PLAN COMMISSION MEETING
Tuesday, March 11, 2025

SUBJECT: Brooklife Church Expansion–Site Plan & Architectural Review & Conditional Use

BASIC INFORMATION	
Project:	Brooklife Church Expansion
Applicant:	Brooklife Church, Inc.
Consulting Engineer:	Abacus Architects Inc.
Consulting Architect:	Abacus Architects Inc.
Request:	Site Plan & Architectural Review & Conditional Use
Staff Recommendation:	Approve with Conditions

BROOKLIFE CHURCH MUKWONAGO, WISCONSIN SITE LIGHTING	DRAWN BY : LB DATE : FEB 11, 2025 SCALE : 1/64" = 1'-0"	REVISIONS		
		#	DATE	
		#	DATE	COMMENTS

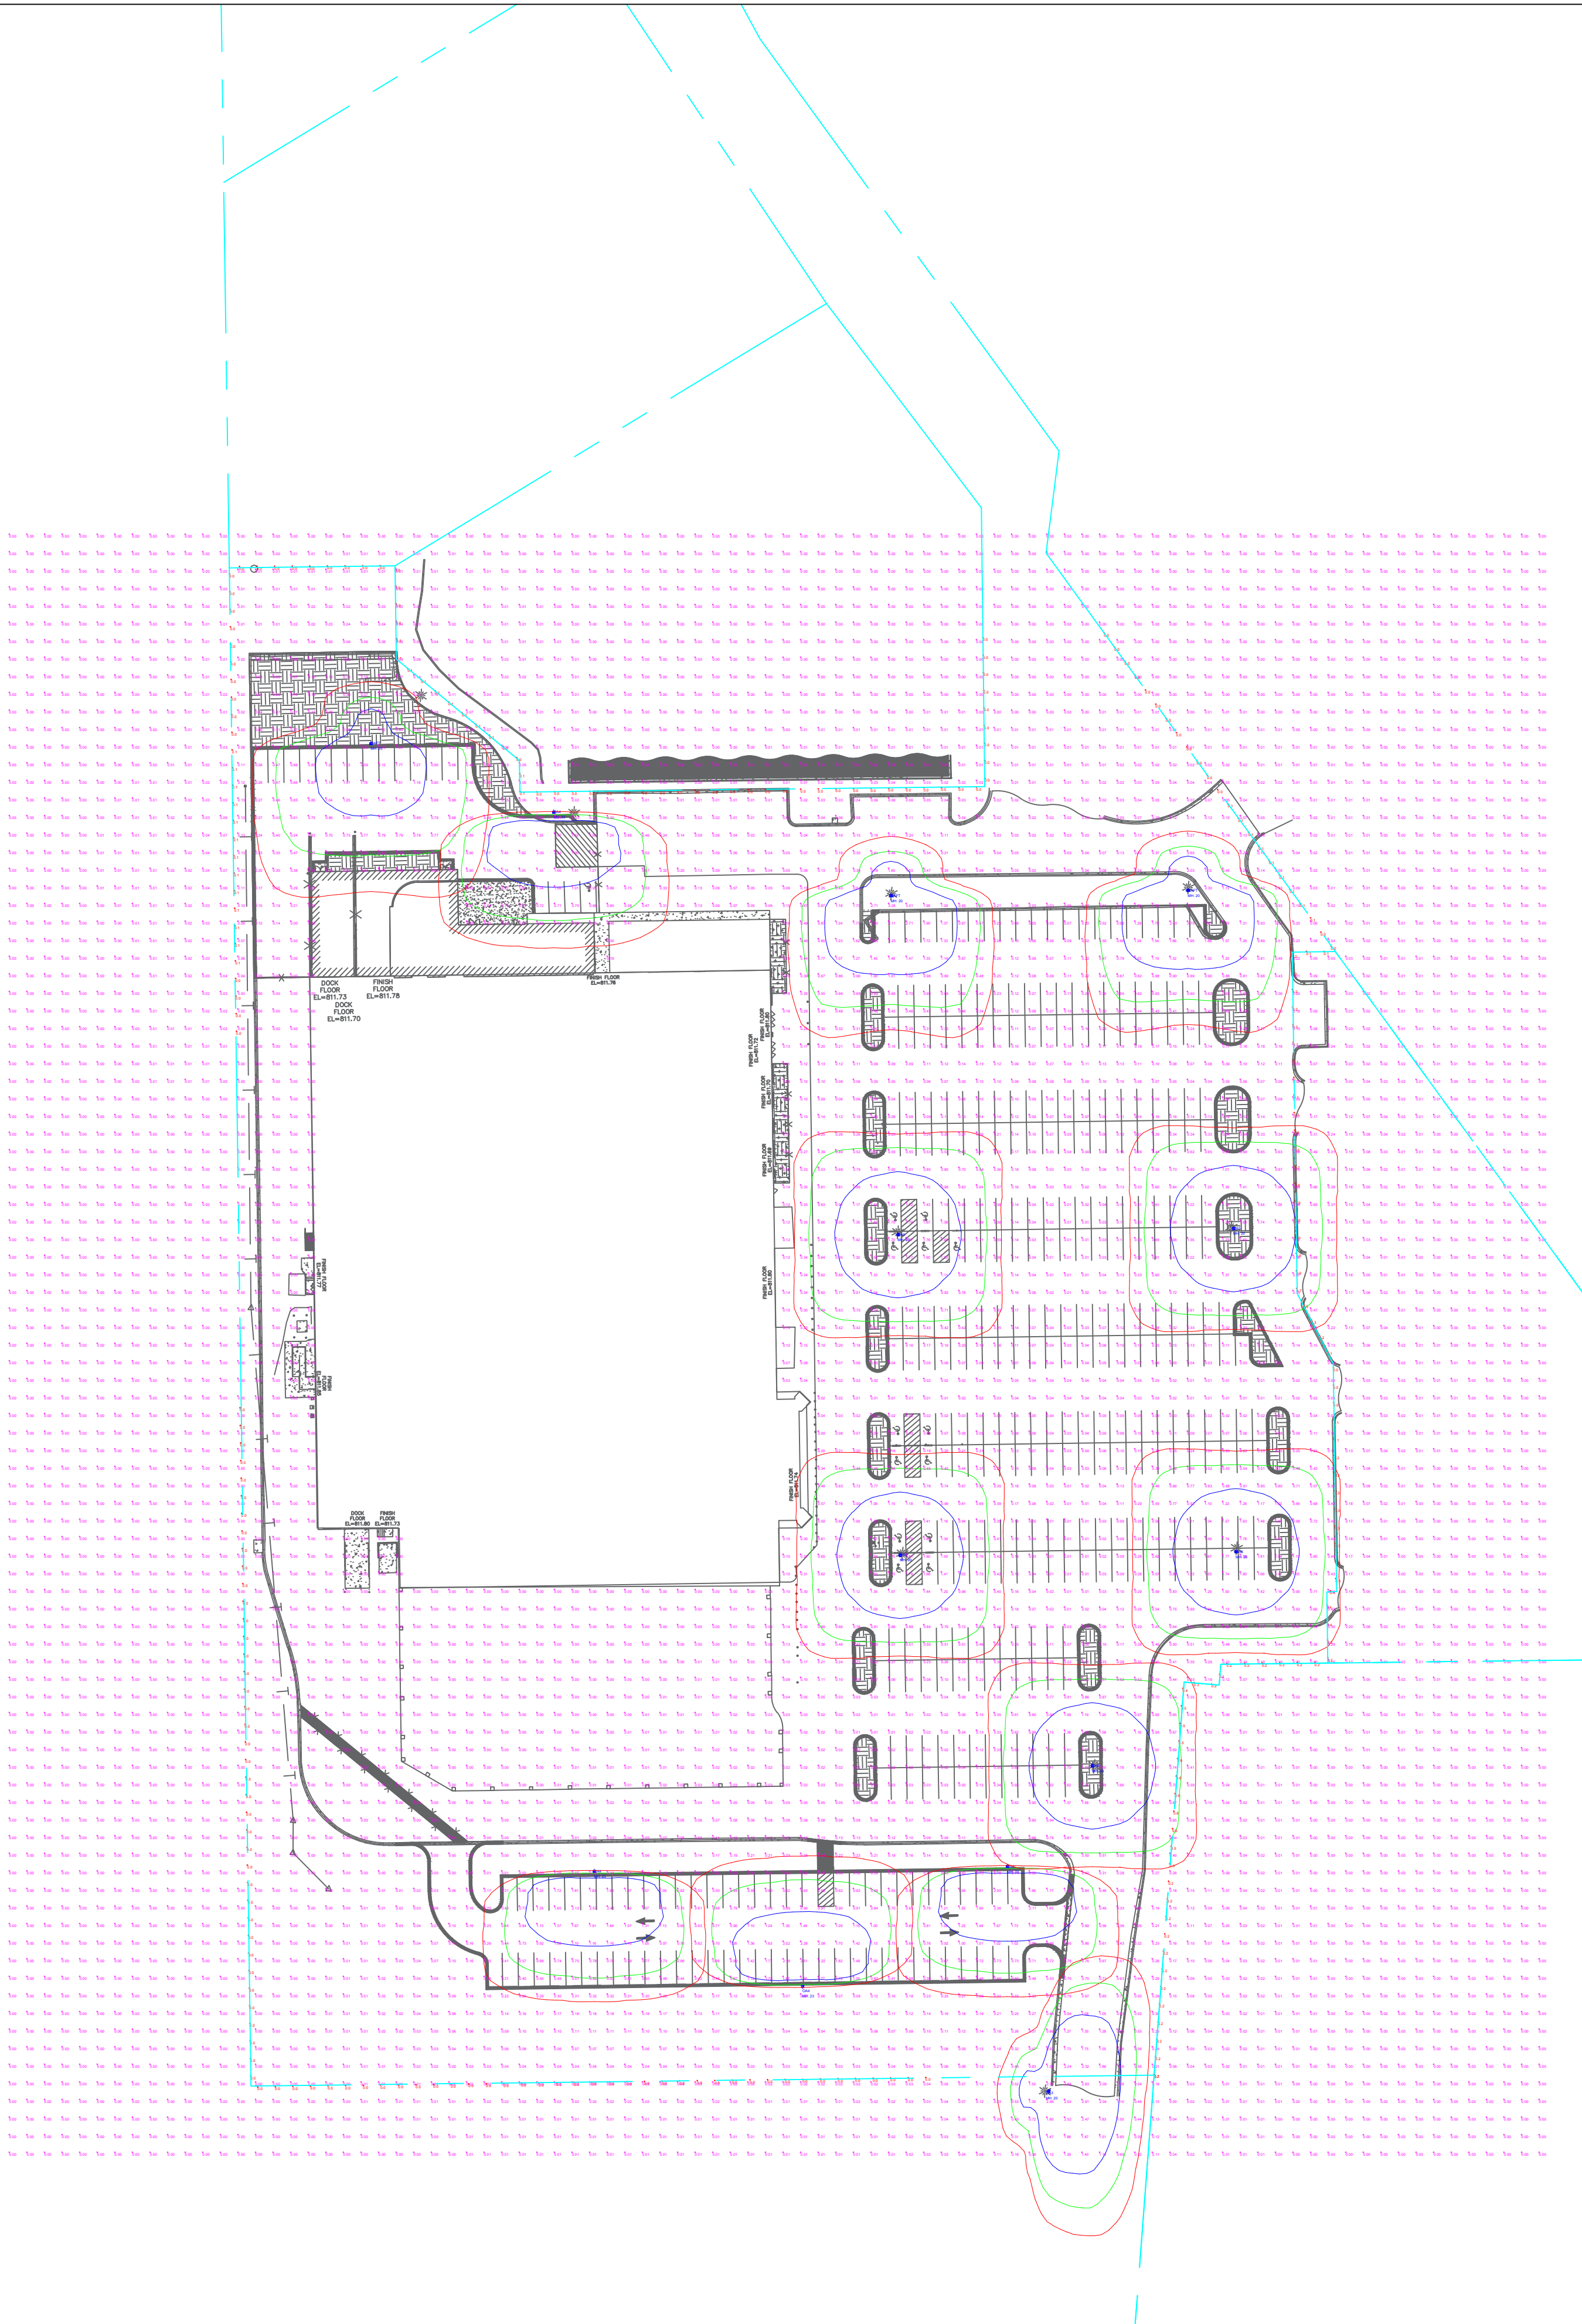
north of the property. Lighting plan will need to be revised to demonstrate zero footcandles of light at all property lines.
